57 Cutler Rd, CLONTARF, NSW - arborist - 13.9.2022

Aborist Report from RainTree Consulting goes with Original DA approval. Rain Tree Map shows 57's rear tree as Tree 3.

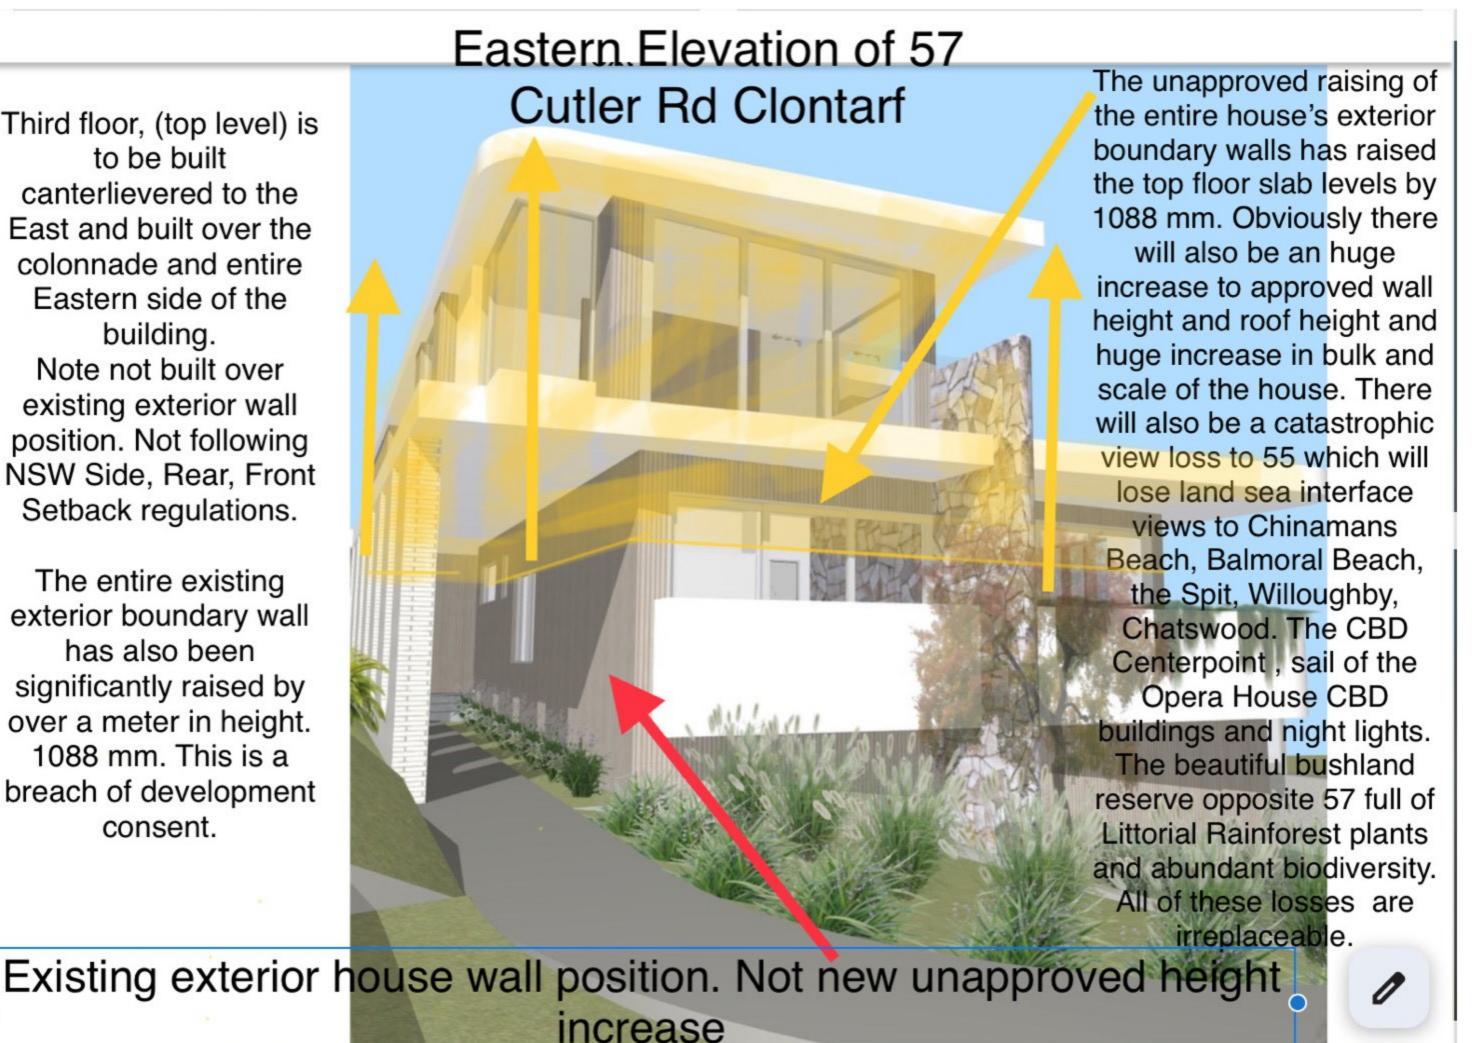
Third floor, (top level) is to be built canterlievered to the East and built over the colonnade and entire Eastern side of the building. Note not built over existing exterior wall position. Not following NSW Side, Rear, Front Setback regulations.

The entire existing exterior boundary wall has also been significantly raised by over a meter in height. 1088 mm. This is a breach of development consent.

8 courses of brick has added an unauthorised 688mm in height to the existing external Eastern wall (76mm brick +10mm of mortar =86mm x 8 brick courses high). The Western walls are newly built atop new foundations and a new slab. This level (first floor) will have an additional 400mm slab on top of the 8 brick courses. This equates to an unapproved breach of 1088mm. The entire Western boundary wall has been newly constructed over a meter higher than what was previously existing.

There is a new 4 meter concrete slab which spans from the rear to the entire Eastern side of the building. It is not approved I discovered after I double checked checked this with the previous Planner Reece Cox. Any vegetation is only from neighbours back yards. In this high wind marine environment, the new concrete and new extensive hard surfaces have created a wind tunnel with many parts of my established gardens being blown right out of the ground. Birds being unable to use the bird baths and railings they have used for over a decade. The new wind vortex makes my rear garden and seating area unusable.

Rain Tree Consulting Arborist Report that went with the Original DA approval's Map shows rear tree at 57 Cutler road as Tree 3. These two trees were already removed in January 2025. Tragically the previous Modification in December 2024 approved their removal. Why is this Modification messing up the tree numbers. I urge council to make sure the other protected trees Tree 1 part of the stand of three trees at the front 2 of which are on my property are not removed or damaged.
